ADDENDUM No. 1

April 12, 2024

**Southfield Fire Stations #4 & #5
PAVING IMPROVEMENTS
0153-23-0180**

This Addendum contains 41 pages.

PROJECT NUMBER: 0153-23-0180
 PM: ZAH
 CITY OF SOUTHFIELD
 SOUTHFIELD FIRE STATIONS 4 & 5 PAVING IMPROVEMENTS
 OAKLAND COUNTY
 UTILITY PLAN

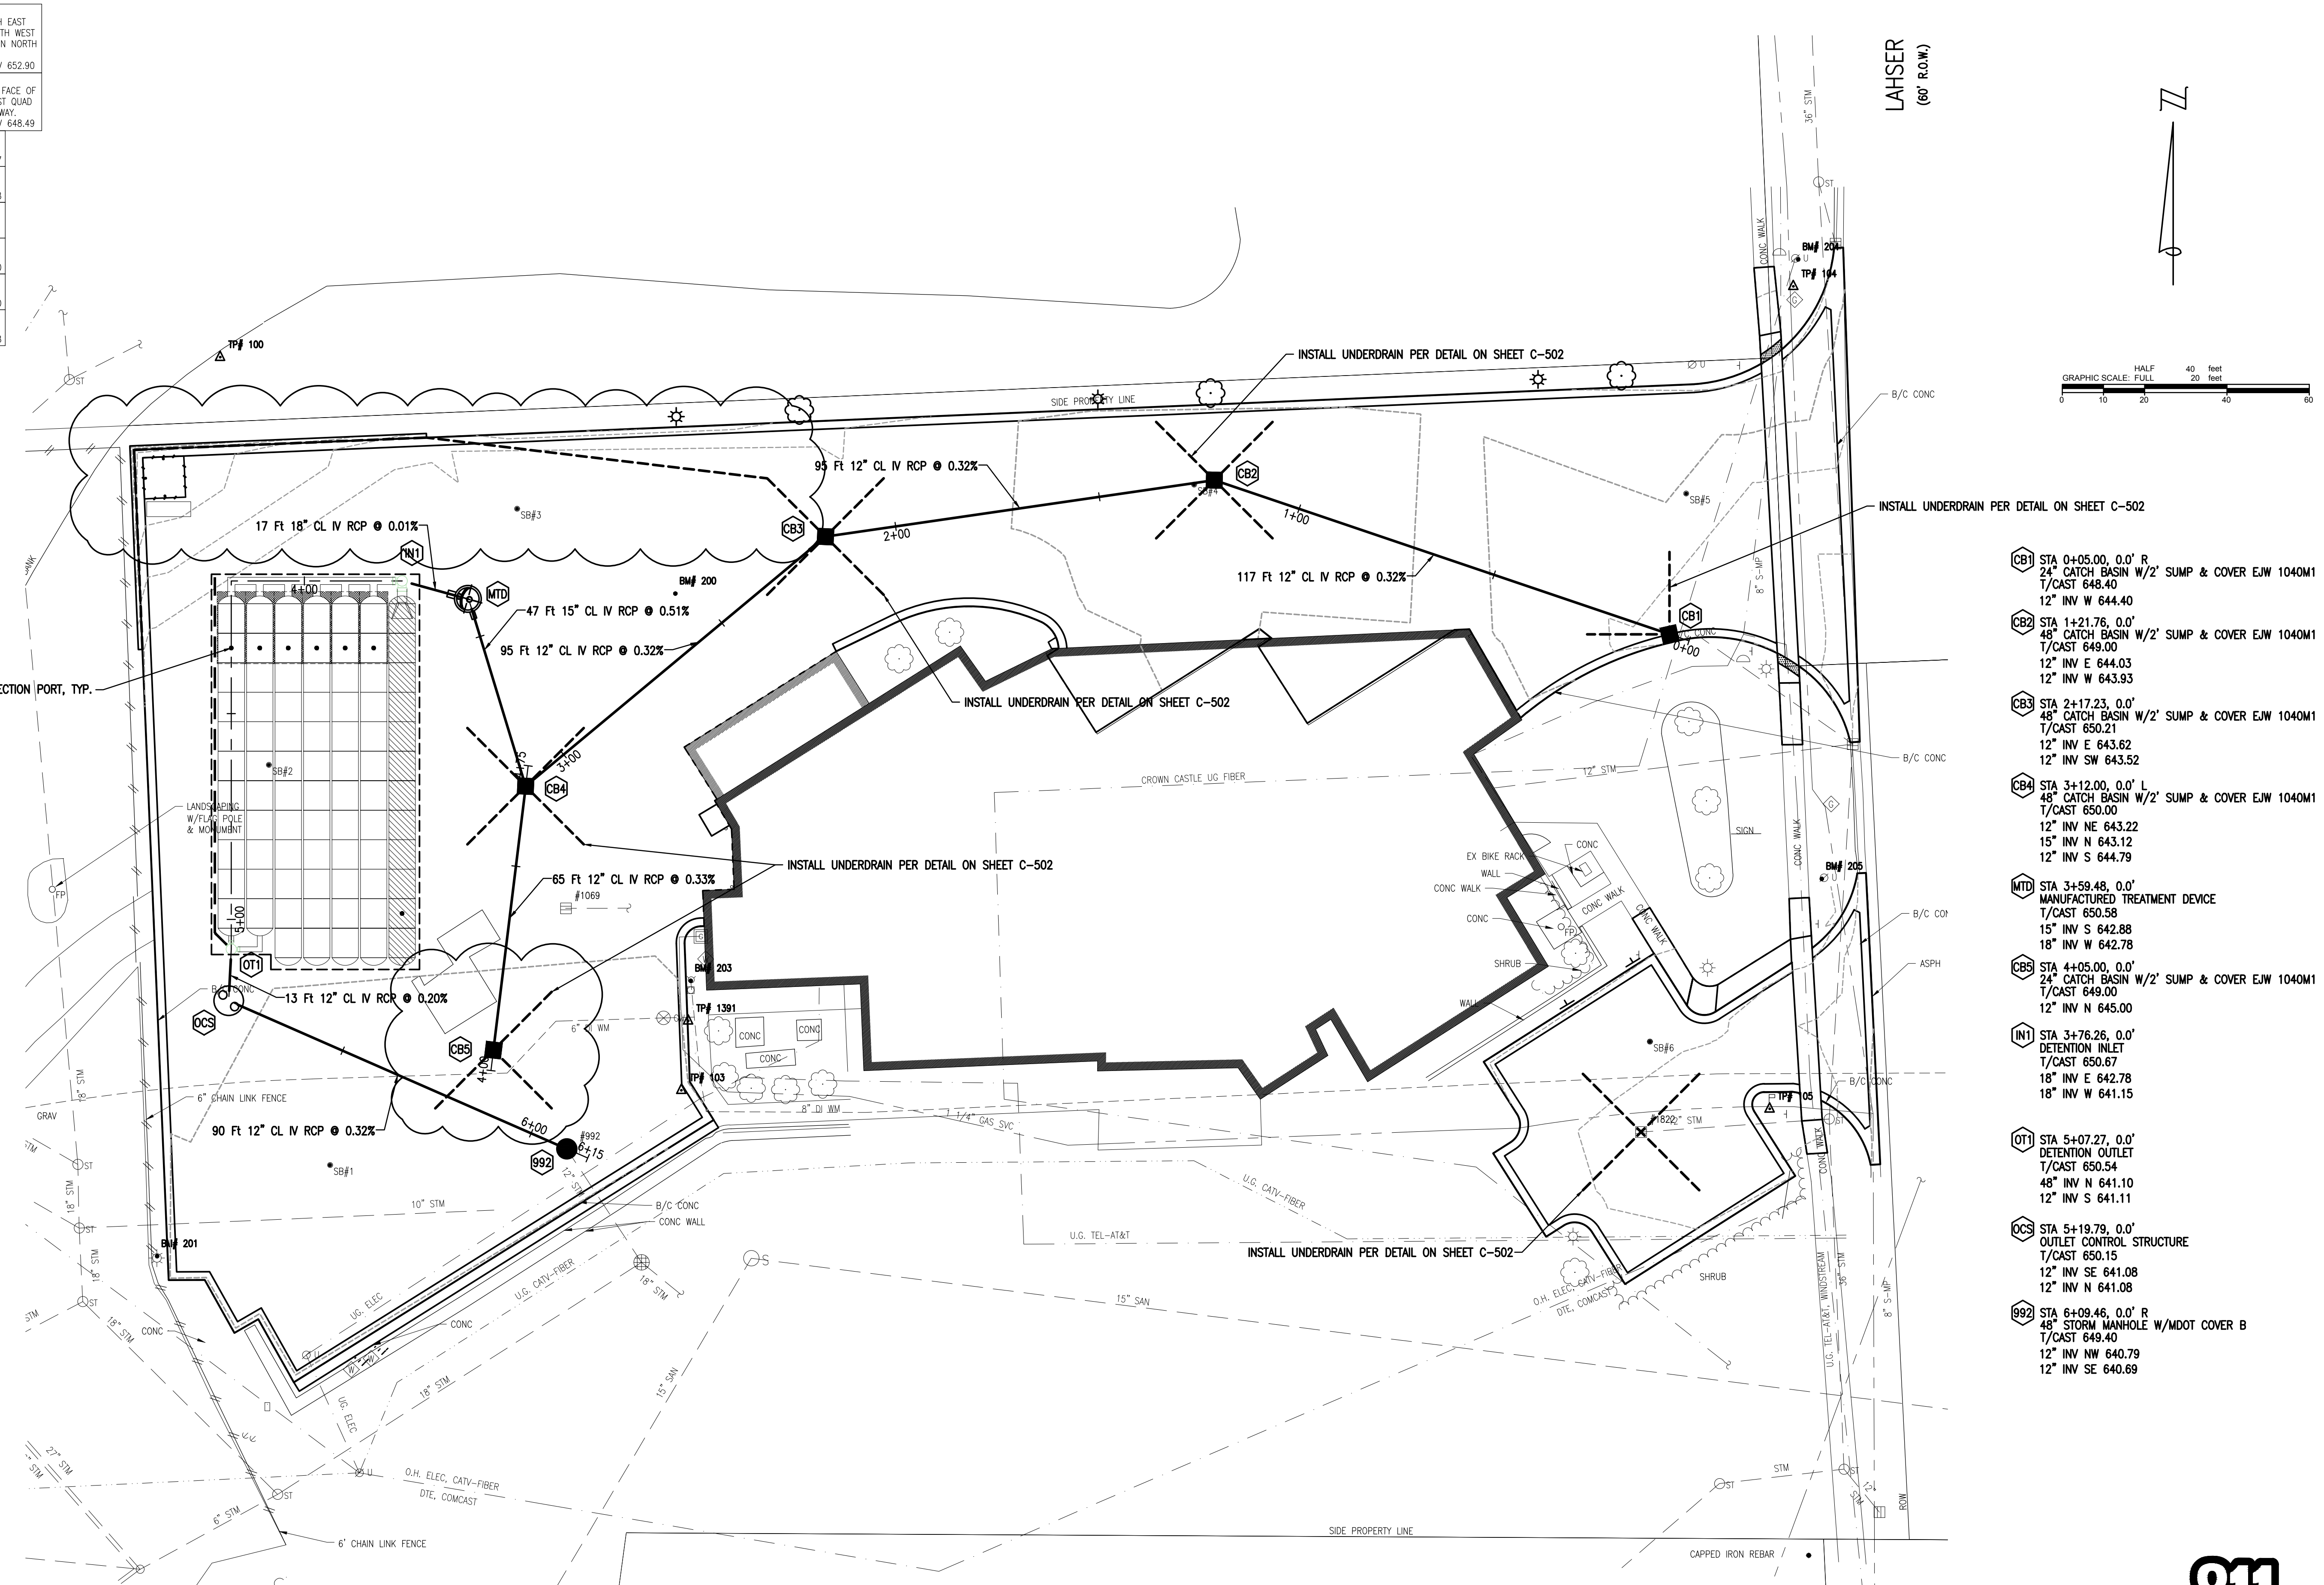
- a. Added underdrain to the proposed retaining wall at the northeastern corner of the site and connected the pipe to proposed catch basin CB3.
 - b. Removed a portion of the proposed underdrain northeast of catch basin CB5.

PROJECT NUMBER: 0153-23-0180
 PM: ZAH
 CITY OF SOUTHFIELD
 SOUTHFIELD FIRE STATIONS 4 & 5 PAVING IMPROVEMENTS
 OAKLAND COUNTY
 STORM SEWER PROFILES

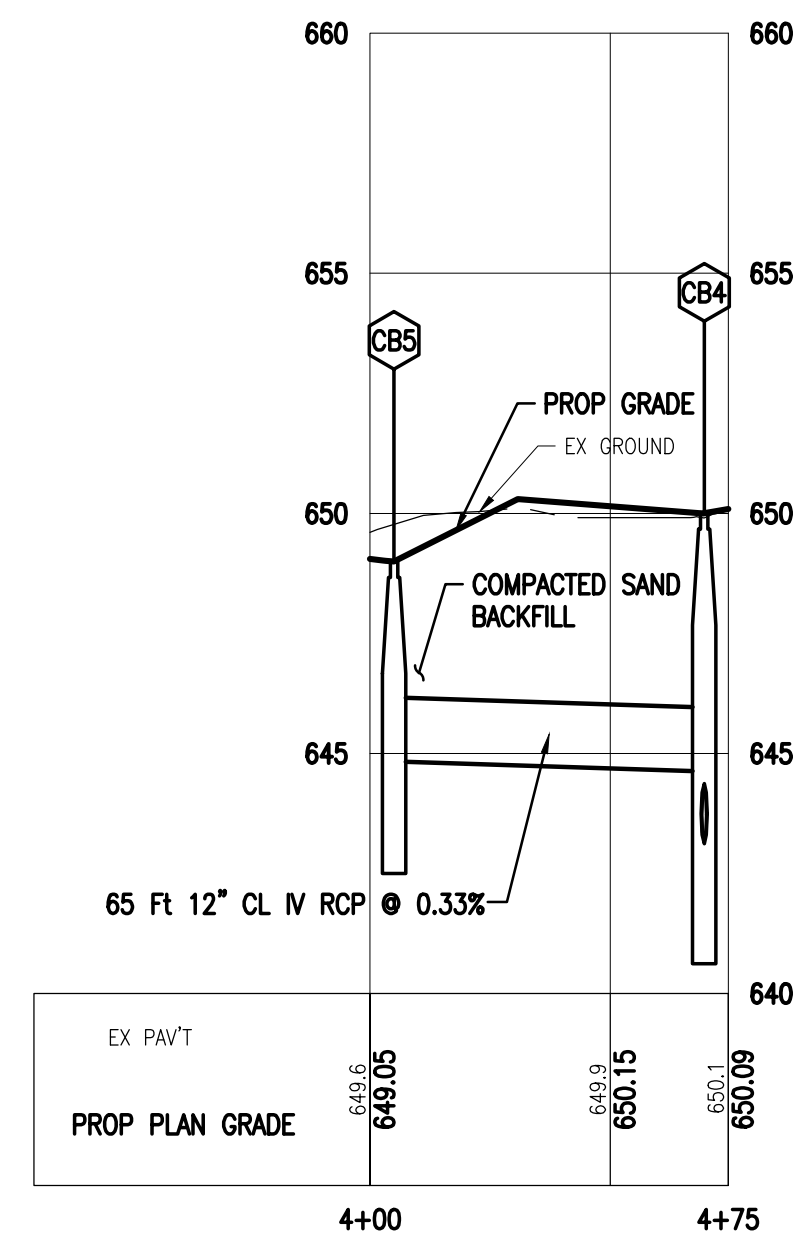
7. Replace plan sheet C-153 with the revised plan sheet attached to this addendum.
 - a. Revised storm structures OT1 and OCS to include a 2' sump.
8. Replace plan sheet C-160 with the revised plan sheet attached to this addendum.

C-160

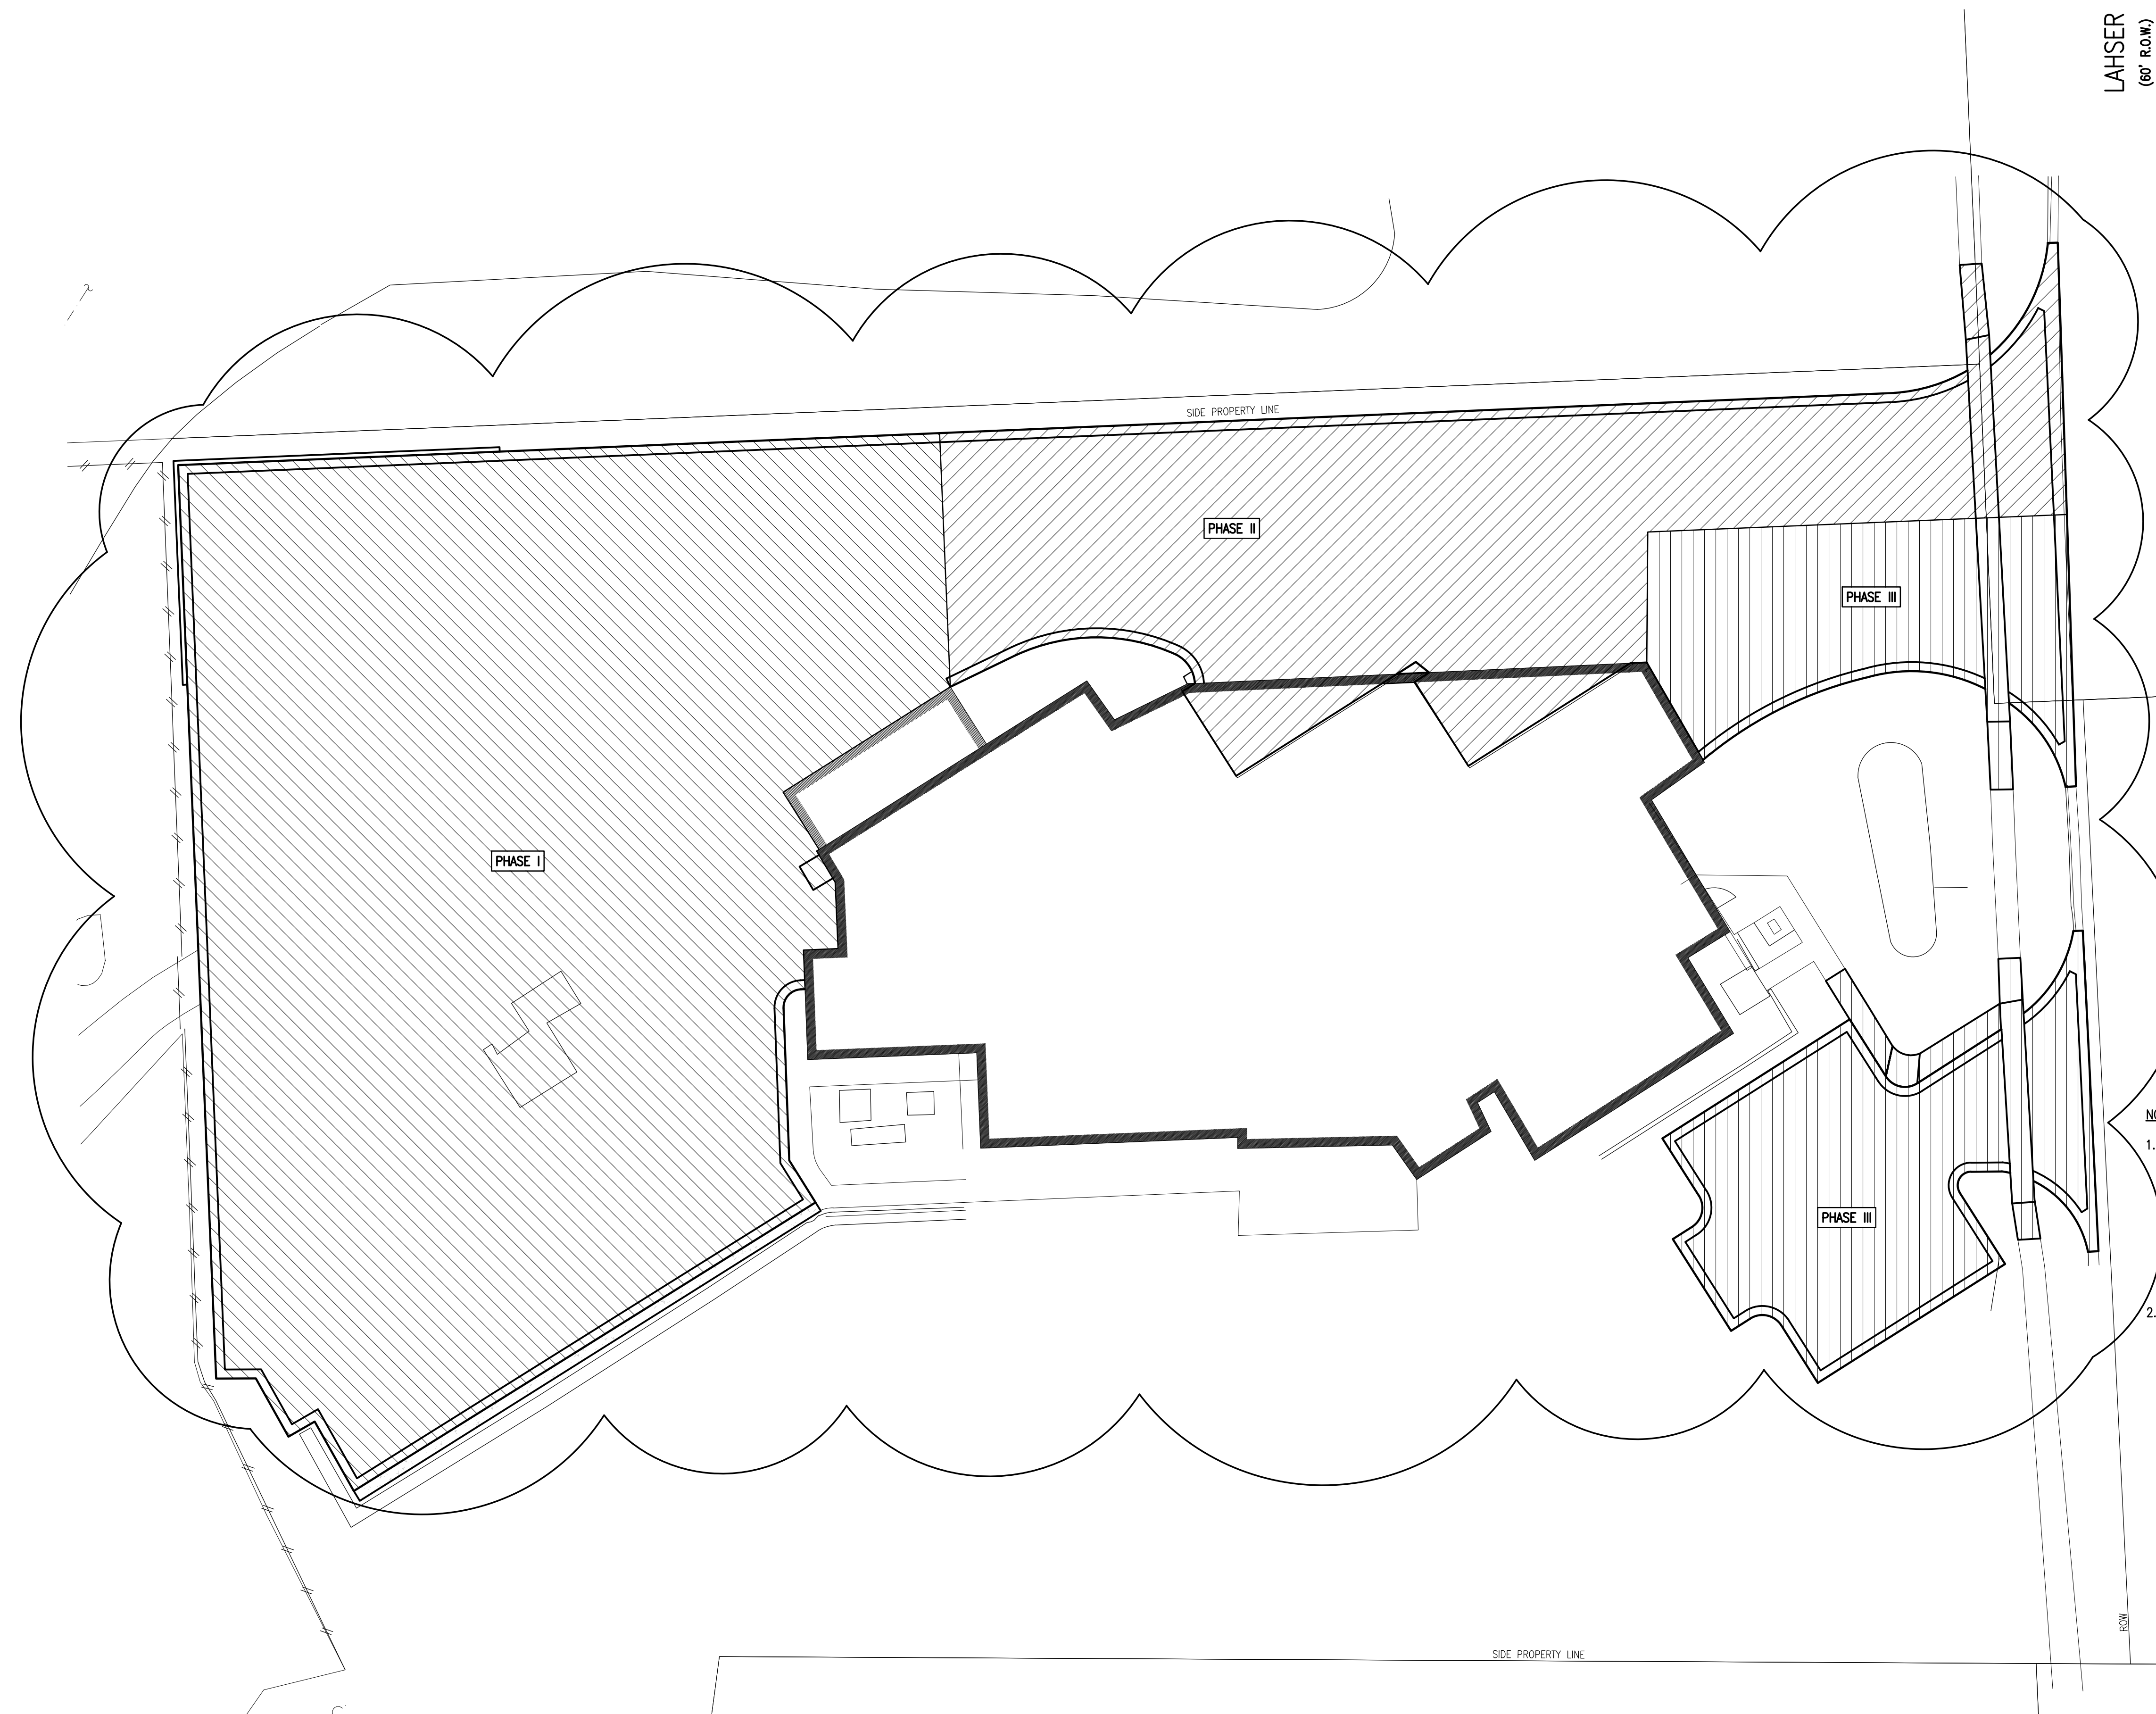
- a. Updated staging plan phasing limits.
9. Replace plan sheet C-501 with revised plan sheet attached to this addendum.
 - a. Revised "Frost Free Slab at Person Door" detail.
